Product Change Notification - SYST-18PVLV994

ERRATA - dsPIC33CH128MP508 Family Silicon Errata and Datasheet Clarification

dsPIC33CH128MP508 Family Silicon Errata and Data Sheet Clarification

FIGURE 1: I/O RAMP

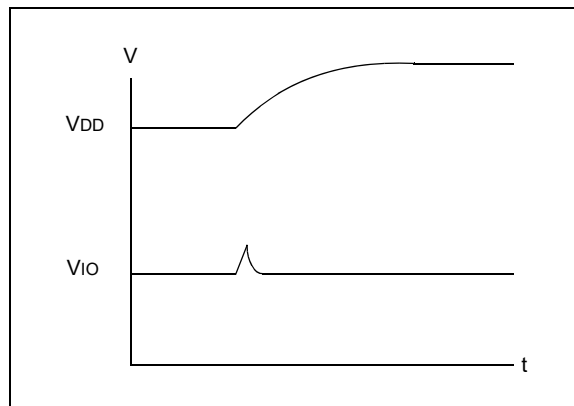
During a fast device power-up, when the V_{DD} ramp is less than 4 mS, the I/O pins may drive up to 100 μA current for a duration of up to 10 μS (Figure 1).

1. Slow down the V_{DD} ramp time (greater than 4 mS for V_{DD} to ramp 0V to 3.3V).
2. Ensure the circuitry that is connected to the pins can endure this pulse.

High-voltage applications with complementary switches should power the high-voltage 200 μSec later than powering the dsPIC[®] device to avoid the current shoot-through. This behavior is specific to each device and not affected by aging.
